The Commission has issued the enclosed Amendment No. 9 to Facility Operating License No. DPR-69 for Unit No. 2 of the Calvert Cliffs Nuclear Power Plant. The amendment is in response to your application dated July 13, 1977, and supplements thereto dated September 30, 1977 and October 5, 1977.

CALVERT CLIFFS UNIT NO. 2

Amendment No. 9  
License No. DPR-69

ATTACHMENT TO LICENSE AMENDMENT NO. 9

Figure 2.1 - 1 REACTOR CORE THERMAL MARGIN SAFETY LIMIT - FOUR REACTOR COOLANT PUMPS OPERATING

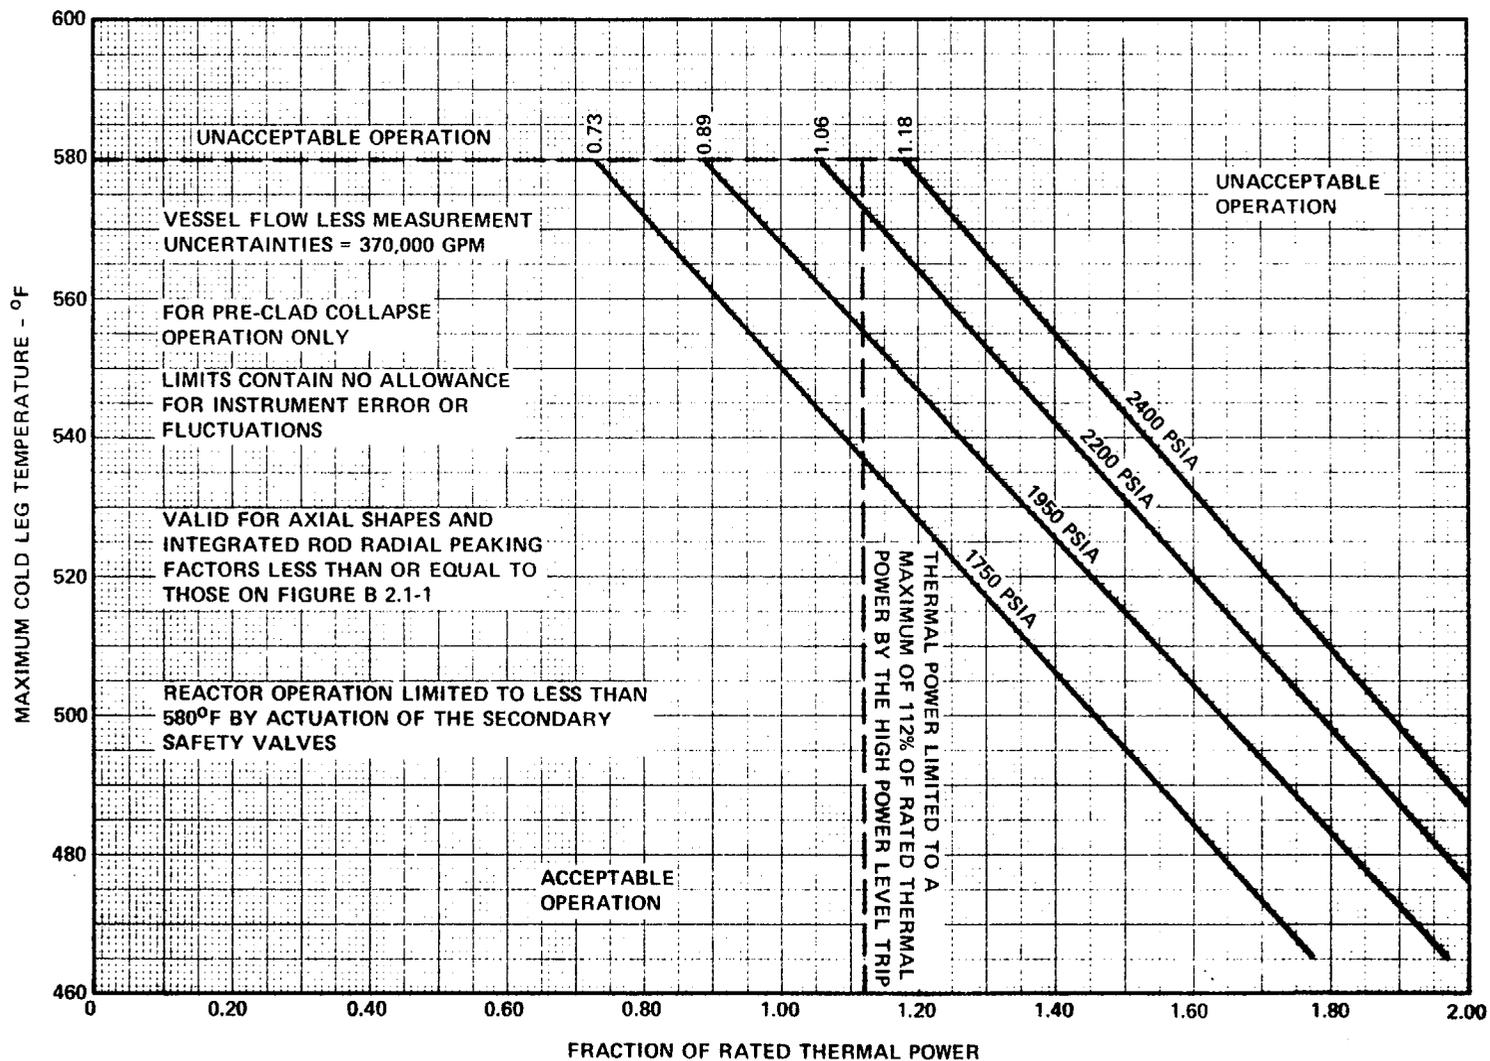
Section 2.1 (Figure 2.1-1) REACTOR CORE THERMAL MARGIN SAFETY LIMIT modified for 2700 MWt operation.

FIGURE 2.2-1  
Peripheral Axial Shape Index,  $Y_1$  Versus Fraction  
of RATED THERMAL POWER

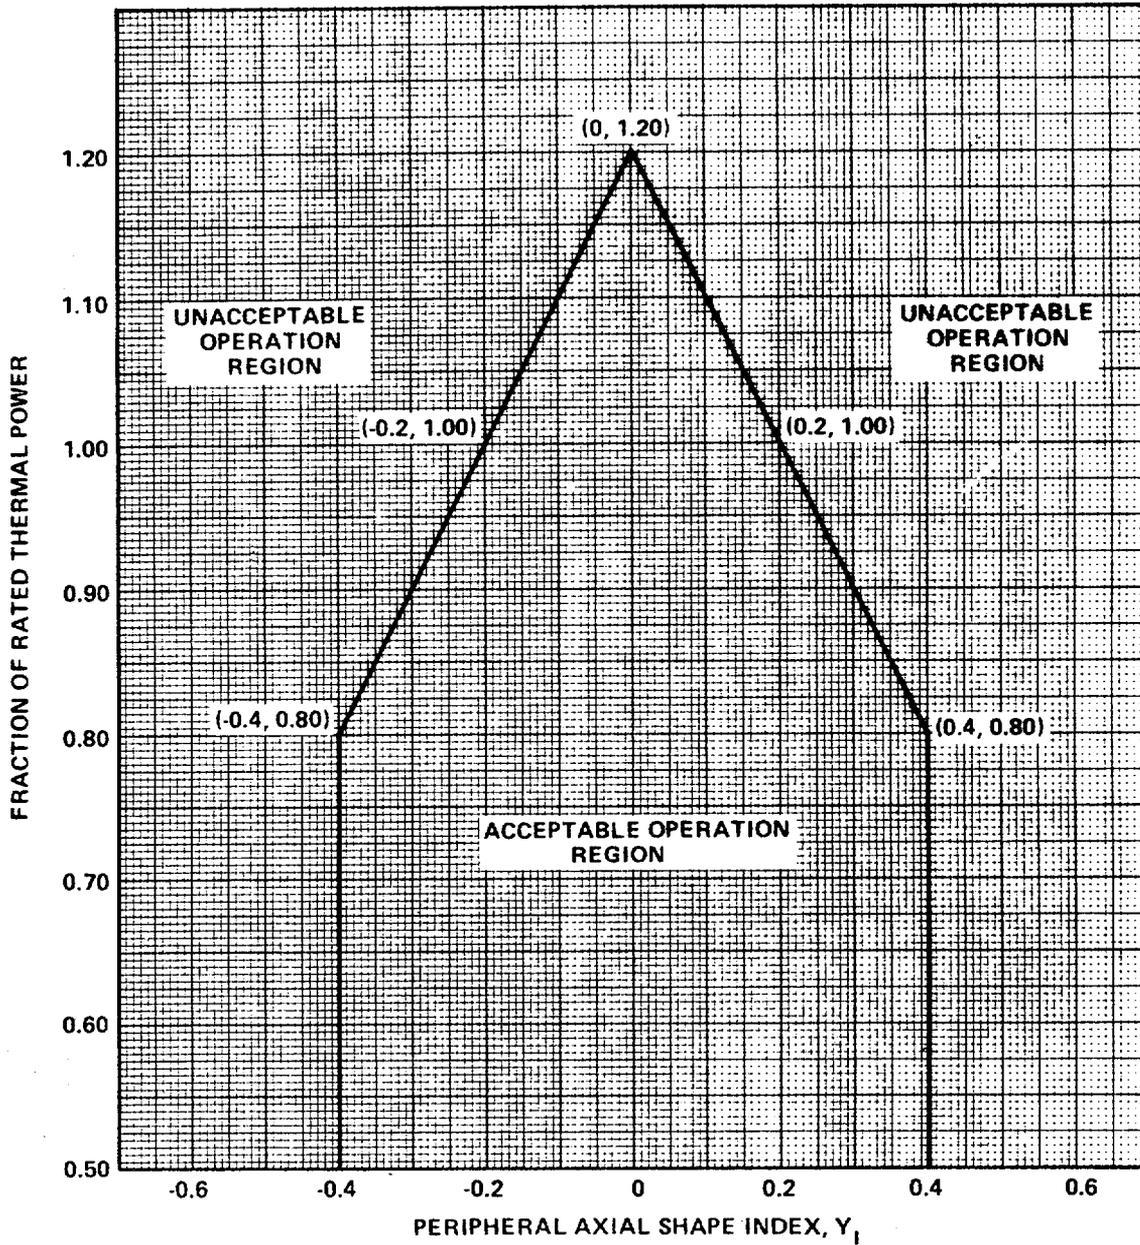
Section 2.2 (Table 2.2-1) AXIAL FLUX OFFSET TRIP SETPOINT modified for 2700 MWt operation by revising Figure 2.2-1.

Figure B2.1-1 Axial Power Distribution for Thermal Margin Safety Limits

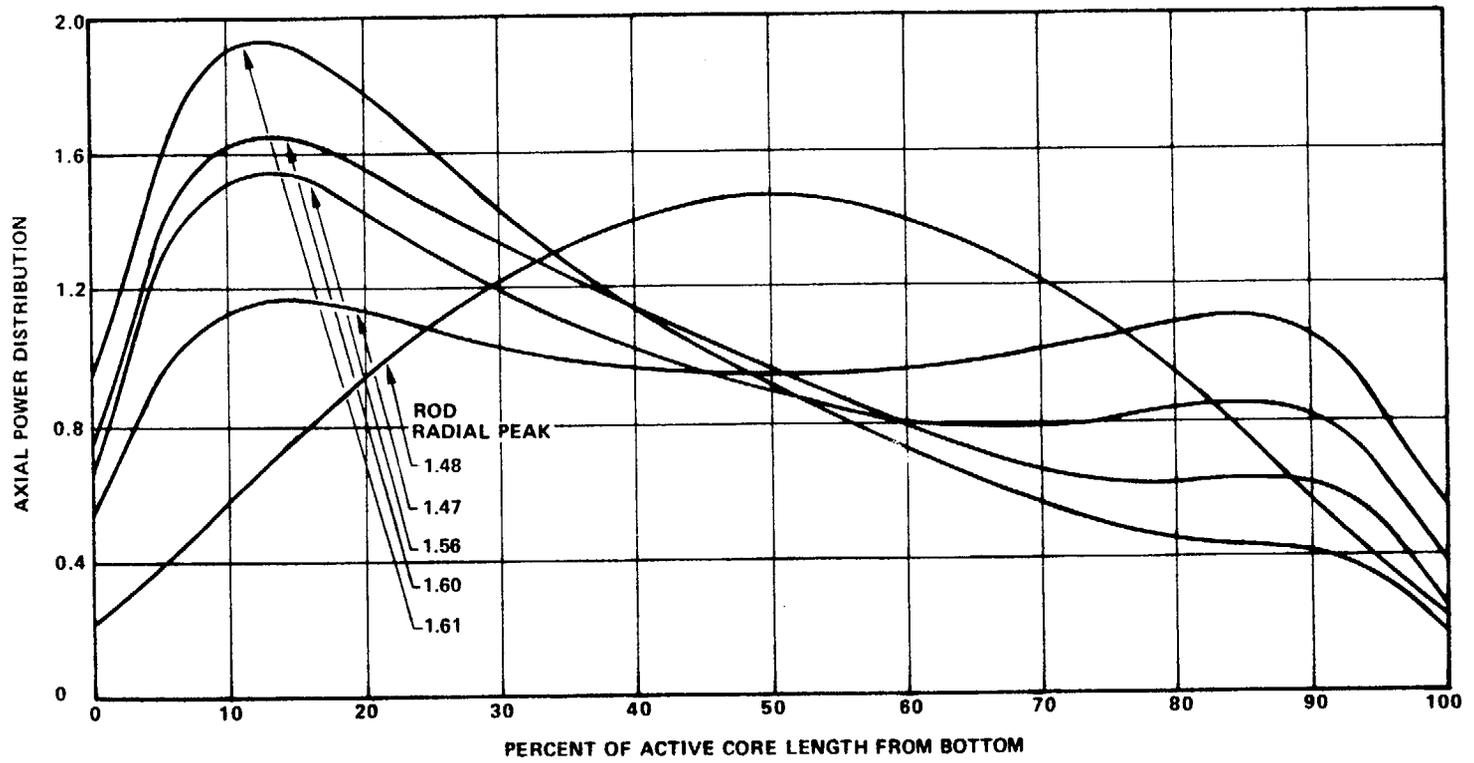
Section 2.1 (Figure B2.1-1) AXIAL POWER DISTRIBUTION FOR THERMAL MARGIN SAFETY LIMITS modified to reflect higher upper limits for axial peaking in Unit 2.

FIGURE 3.1-2

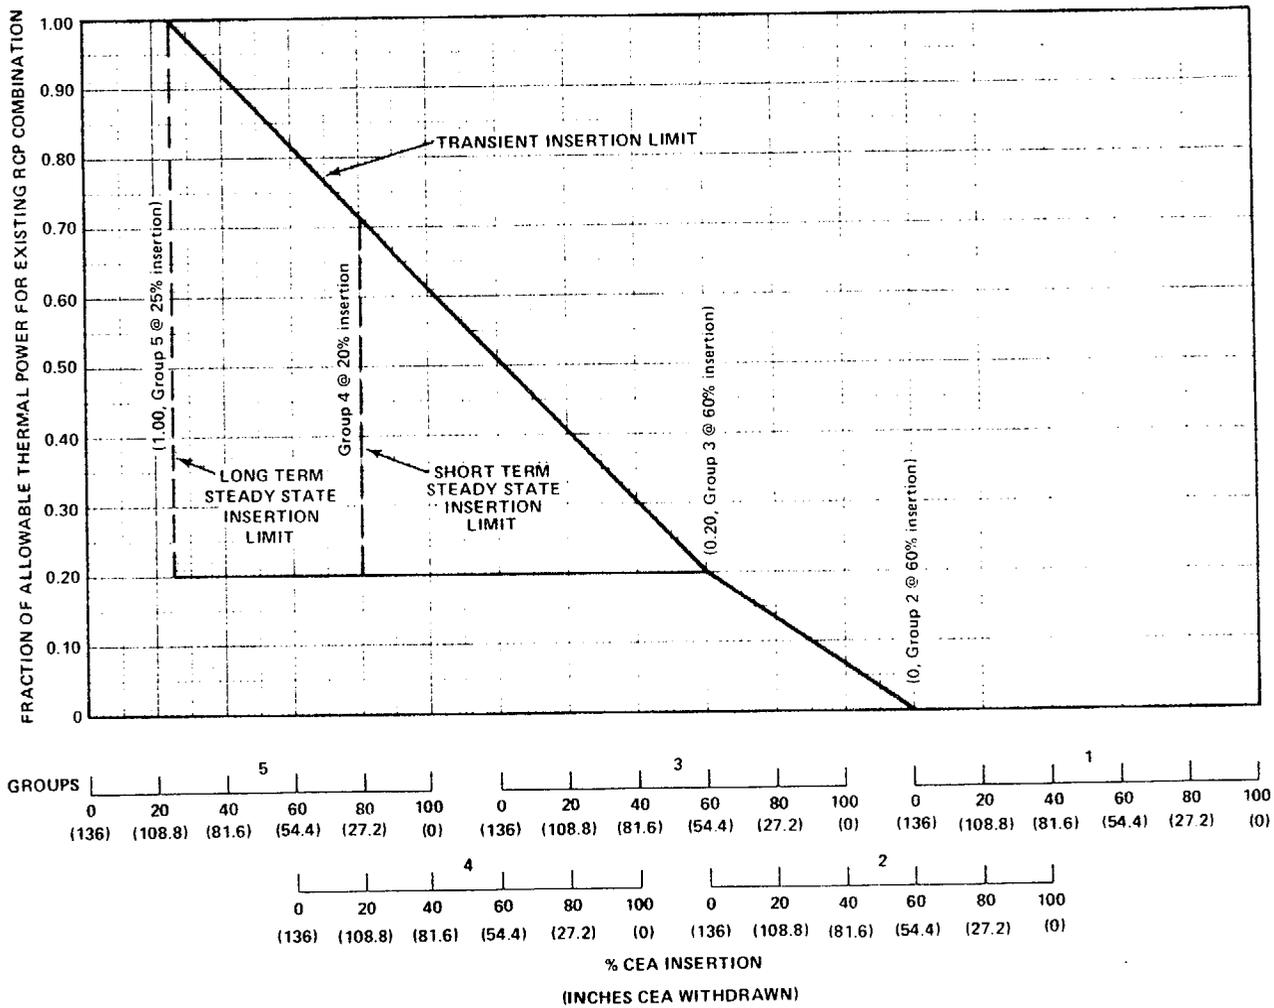
Section 3.1 (Figure 3.1-2) POWER DEPENDENT INSERTION LIMITS modified for 2700 Mwt operation.

Figure 3.2-1 Allowable Peak Linear Heat Rate vs Burnup

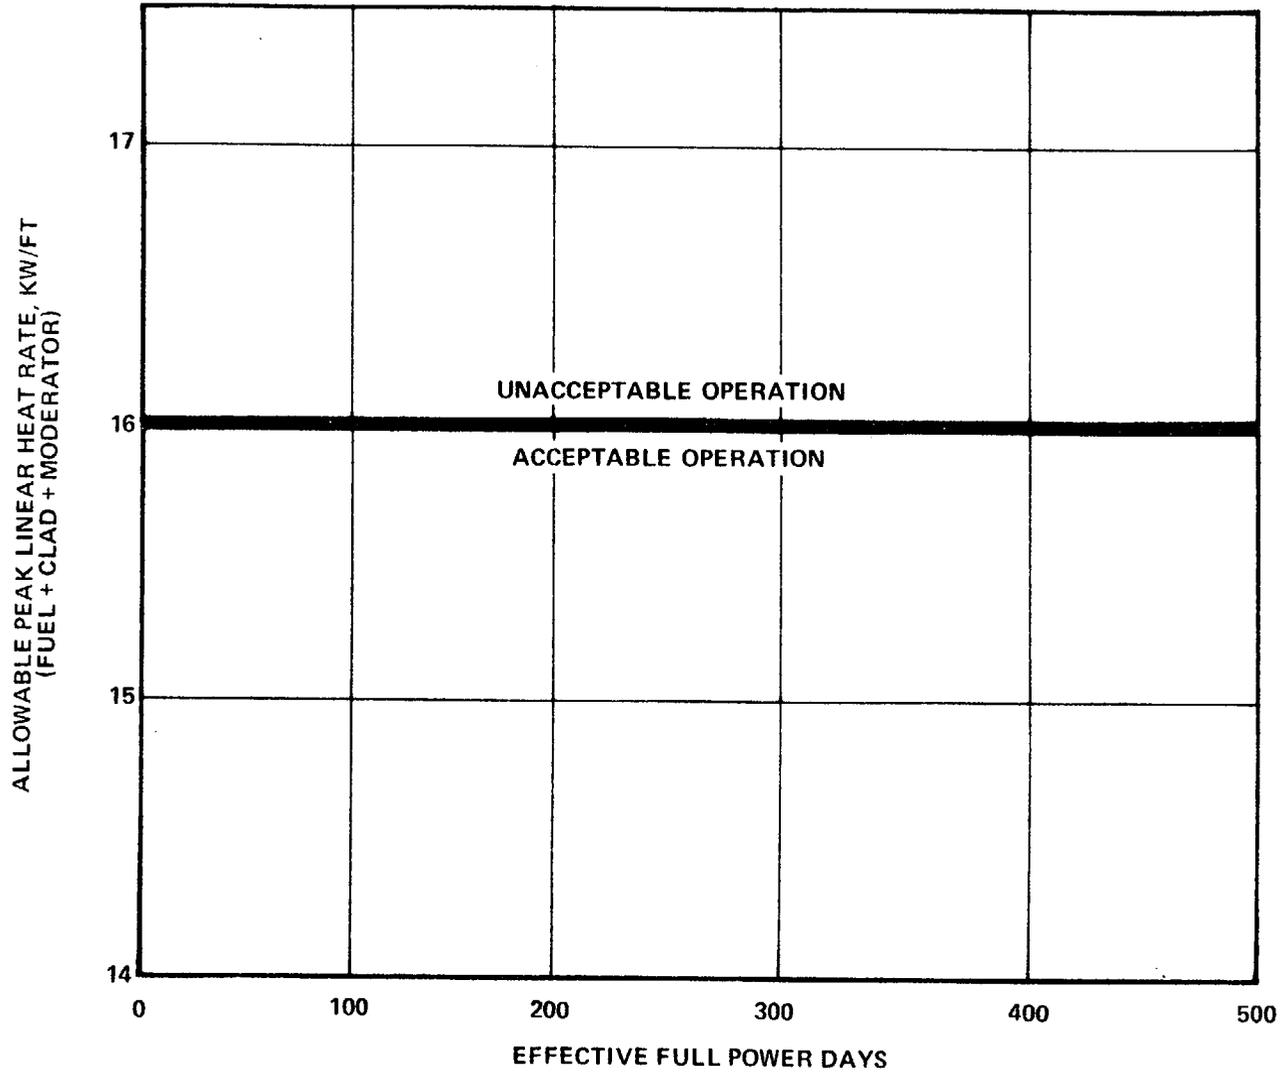
Section 3.2 (Figure 3.1-1) ALLOWABLE PEAK LINEAR HEAT RATE modified to reflect allowable limit for Unit 2 at stretch power.

FIGURE 3.2-2  
 Linear Heat Rate  
 Axial Flux Offset Control Limits

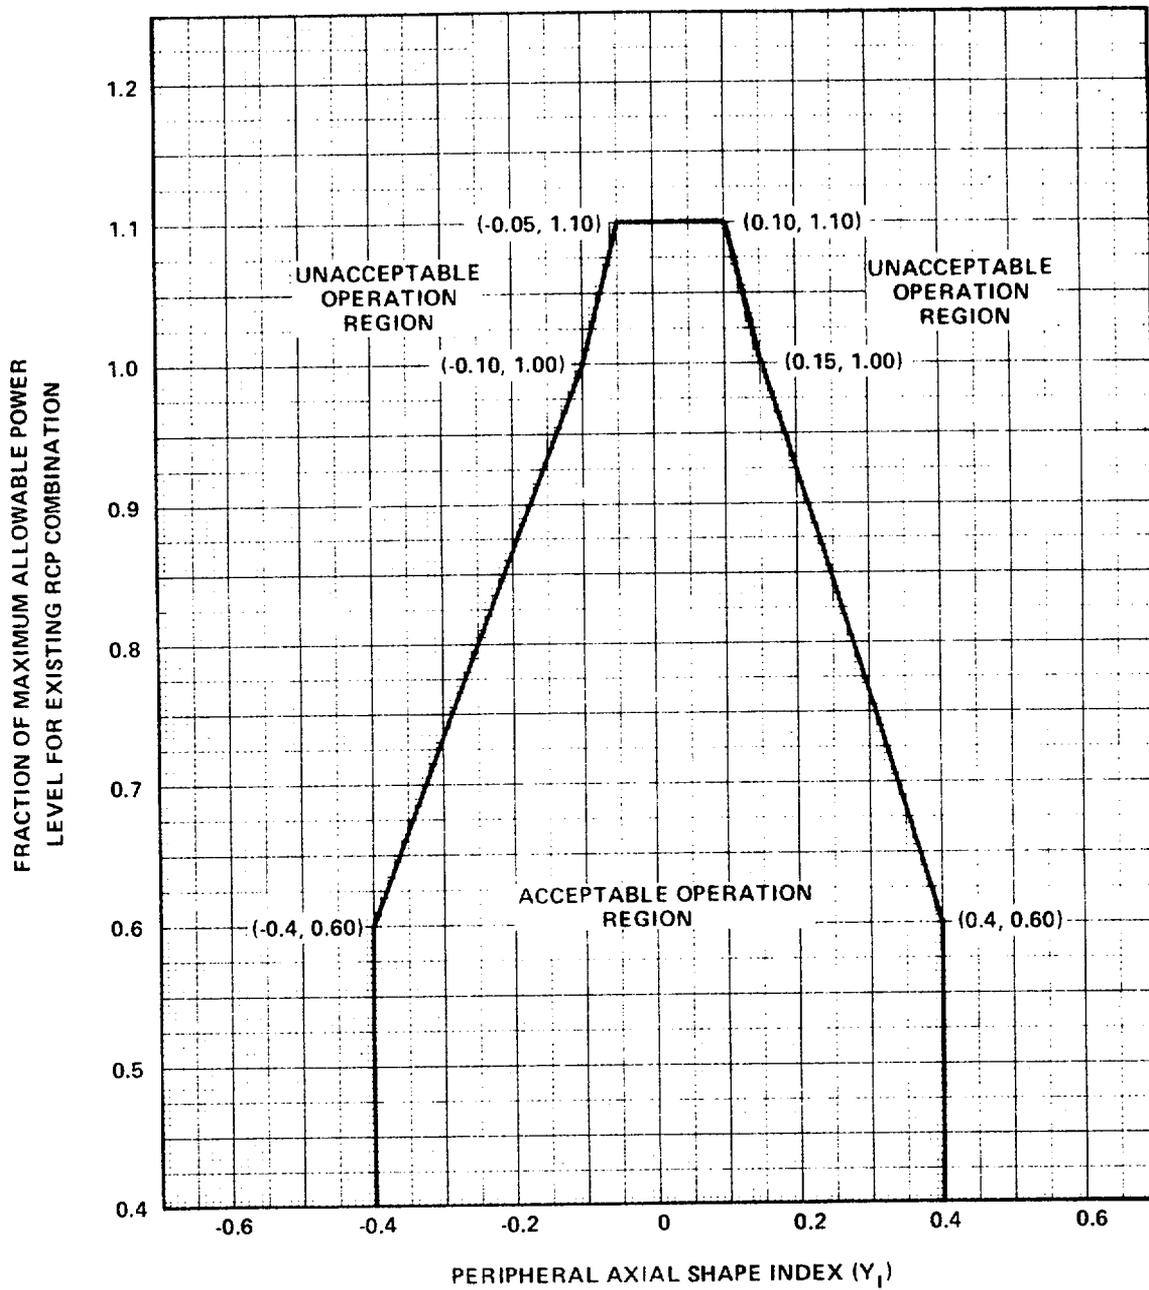
Section 3.2 (Figure 3.2-2) LINEAR HEAT RATE AXIAL FLUX OFFSET CONTROL LIMITS modified for 2700 Mwt operation.

**FIGURE 4.2-1**  
Augmentation Factors vs Distance from Bottom of Core

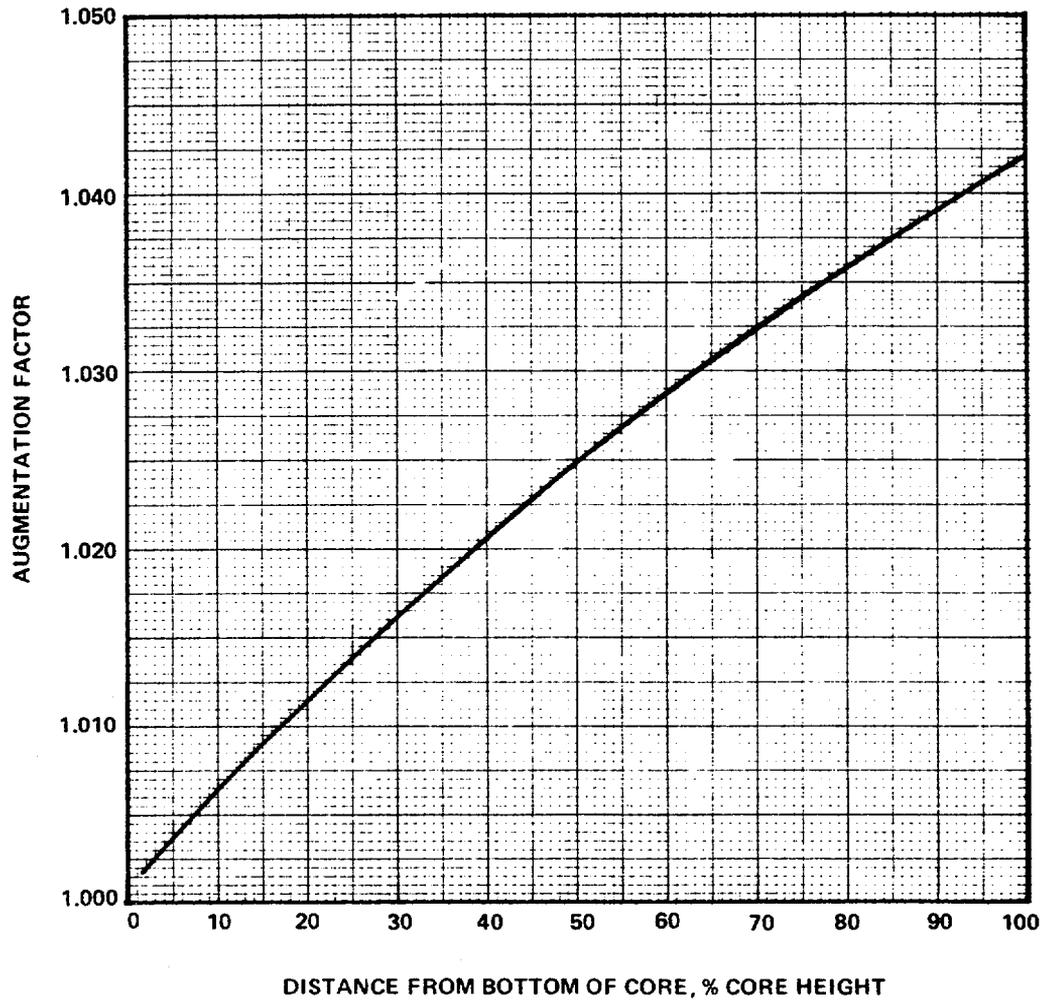
Section 4.2 (Figure 4.2-1) AUGMENTATION FACTOR modified to reflect improved densification characteristics of Unit 2 fuel.

FIGURE 3.2-3  
Total Radial Peaking Factor Versus Allowable Fraction  
of RATED THERMAL POWER

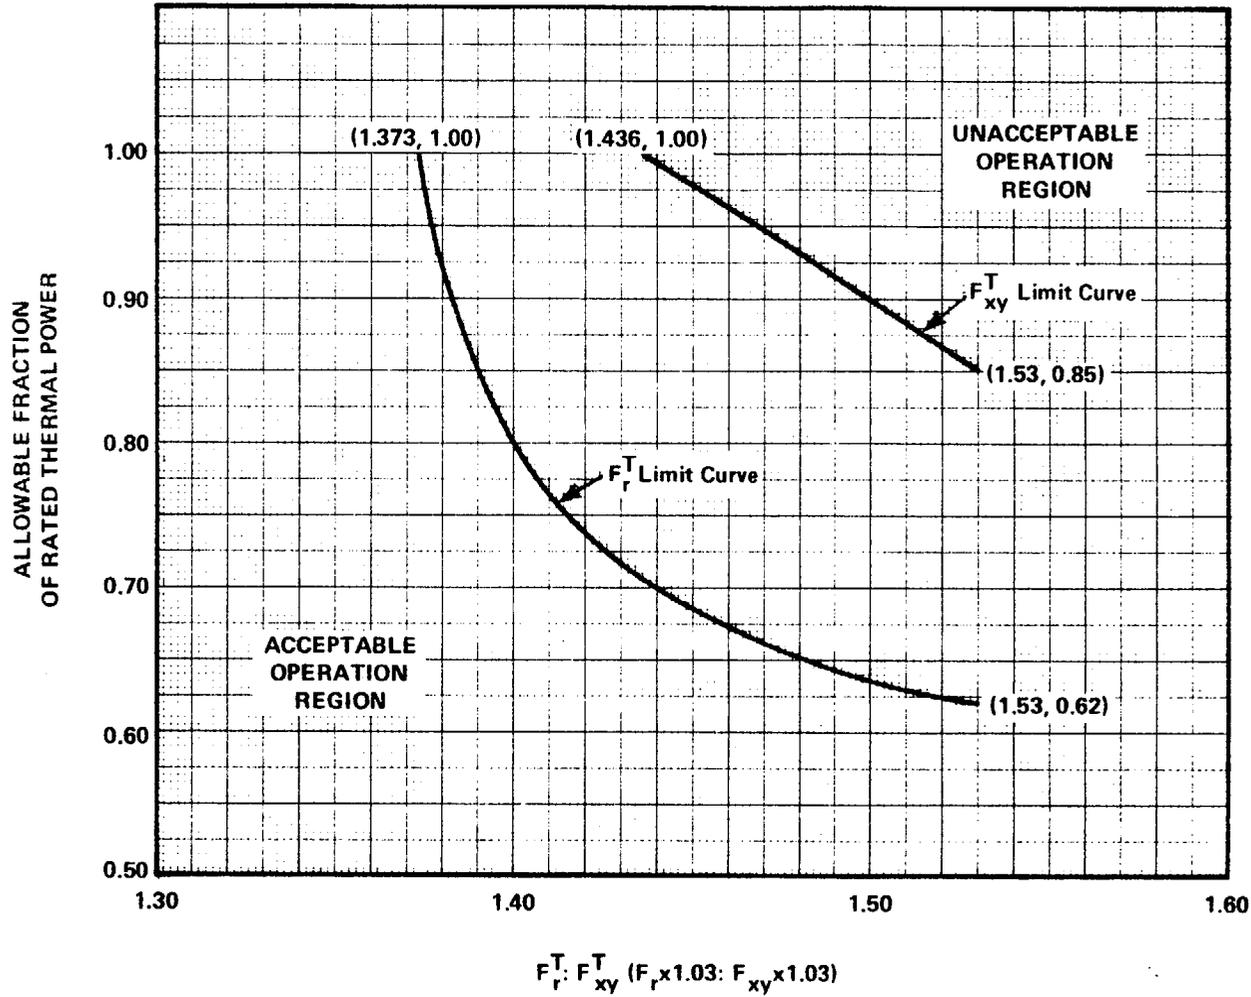
Section 3.2.2 and Figure 3.2-3 TOTAL PLANAR RADIAL PEAKING FACTOR modified to reflect reduced value for Unit 2.

Section 3.2.3 and Figure 3.2-3 TOTAL INTEGRATED RADIAL PEAKING FACTOR modified to reflect reduced value for Unit 2.
